# UNITED STATES PATENT AND TRADEMARK OFFICE

10/791,075

<b>Office Action Summary</b>	<b>Application No.</b> 10/791,075	<b>Applicant(s)</b> WIETING ET AL.	
	<b>Examiner</b> LESLIE R. DEAK	<b>Art Unit</b> 3761

## DETAILED ACTION

blood and collect in the upper portion of the housing (see paragraphs 0058-0059). See also Stringer FIG3, as annotated by the Examiner, below.

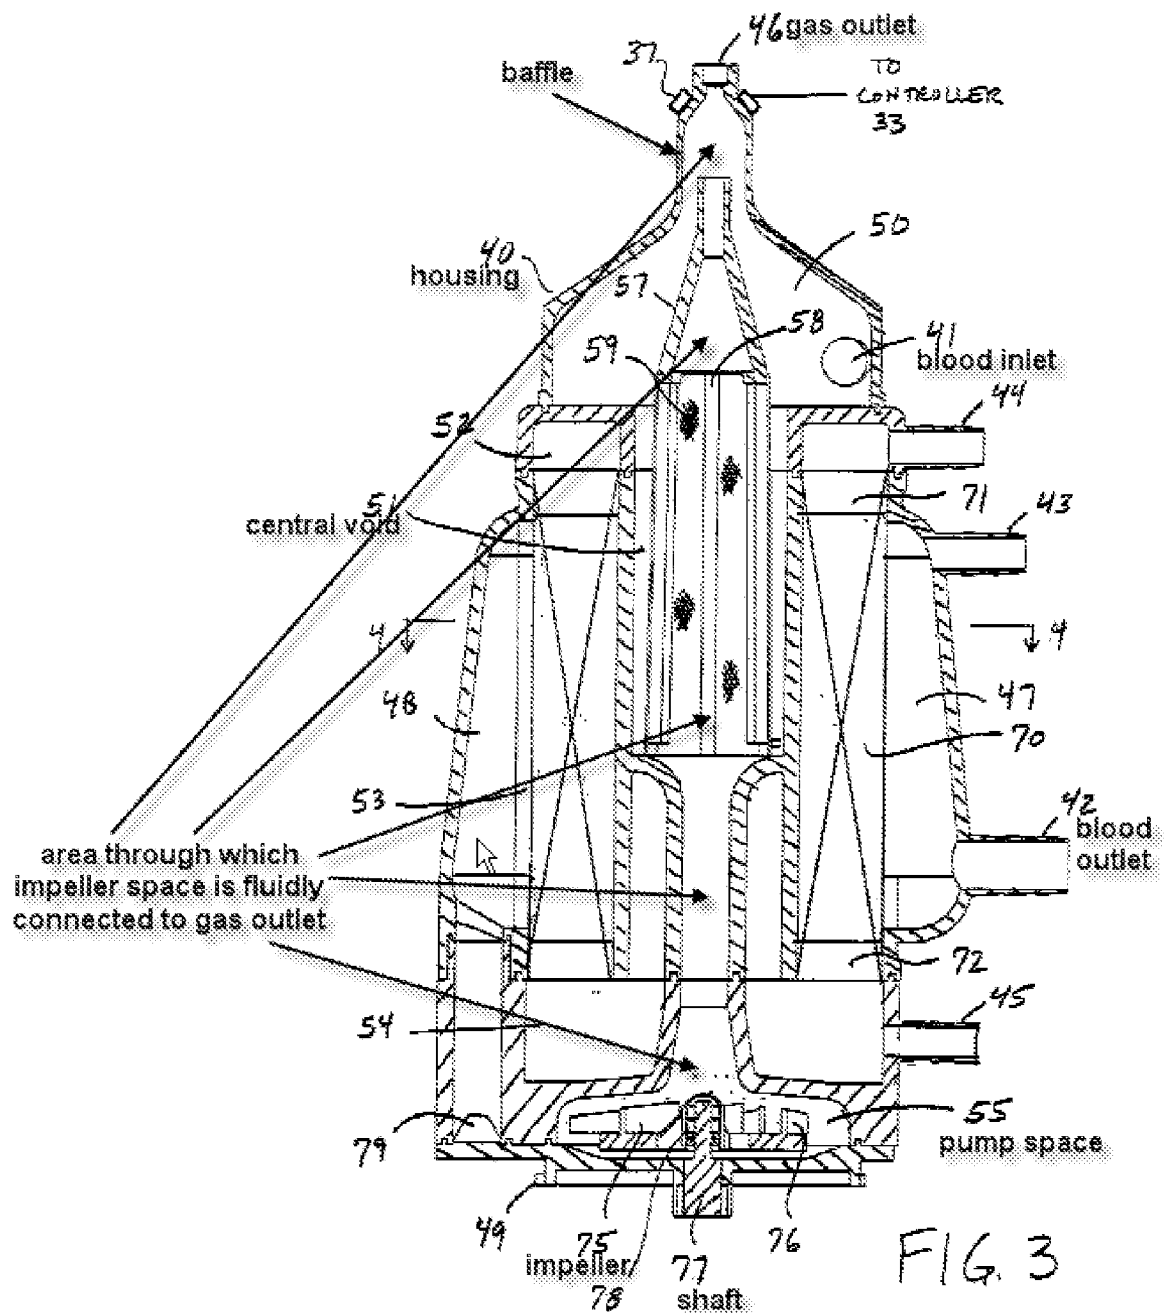
at a central axis of the shell or housing, a blood inlet port 41 affixed to the chamber defined by housing 40, and a blood outlet port 42 located at the radial periphery of the shell or housing (see FIG 3). While the illustration shows a filter material 59 between the impeller and the gas outlet, Stringer discloses that blood flows through the filter material 59 towards impeller 75, indicating that the two spaces on either side of the filter material 59 are in a single chamber. If they were in separate chambers, blood would not be able to flow from the gas outlet area to the impeller.

With regard to applicant's limitation that the chamber diameter is approximately constant between the blood inlet, blood outlet, and impeller, the Stringer device meets the limitation, since the diameter of the shell or housing 40 is illustrated as having similar diameters at pump space 55 and blood inlet 41. While blood outlet 42 is located in a portion of the device with a larger diameter than at pump space 55 and blood inlet 41, it is not dramatically out of line with the other diameters, creating a chamber of "approximately" constant diameter between the three elements.

With regard to applicant's limitation that the impeller is configured to directly rotate a volume of blood within the chamber, the Stringer device comprises a rotating impeller 75 that directly contacts the blood to move it through the apparatus (see paragraph 0061). A rotating impeller necessarily rotates a volume of fluid that flows past the impeller. Therefore, the impeller disclosed by Stringer directly rotates blood as claimed by applicant. Stringer discloses that the impeller 75 and construction of the housing 40 cause the blood to rotate about the chamber (thus creating a centrifugal force within the blood) until air or other gases entrained in the blood separate from the

With regard to claim 3, Stringer illustrates that the gas outlet 46 is surrounded by a cylindrical, narrow portion of the housing, which acts as a baffle, directing flow therethrough (see Stringer FIG 3).

With regard to claim 10, Stringer illustrates that blood inlet port 41 is located higher than blood outlet port 42 (see FIG 3).

With regard to claim 12, Stringer illustrates that gas outlet port 46 is located at the top of the housing 40, higher than the blood inlet port 41 and blood outlet port 42 (see FIG 3).

Applicant argues that the impeller disclosed by Stringer is not located in the same chamber where the air is removed from the blood. However, Stringer's FIG 3 shows a filter material 59 between the impeller and the gas outlet, but Stringer discloses that blood flows through the filter material 59 towards impeller 75, indicating that the two spaces on either side of the filter material 59 are in a single chamber. If they were in separate chambers, blood would not be able to flow from the area of the gas outlet to the impeller.
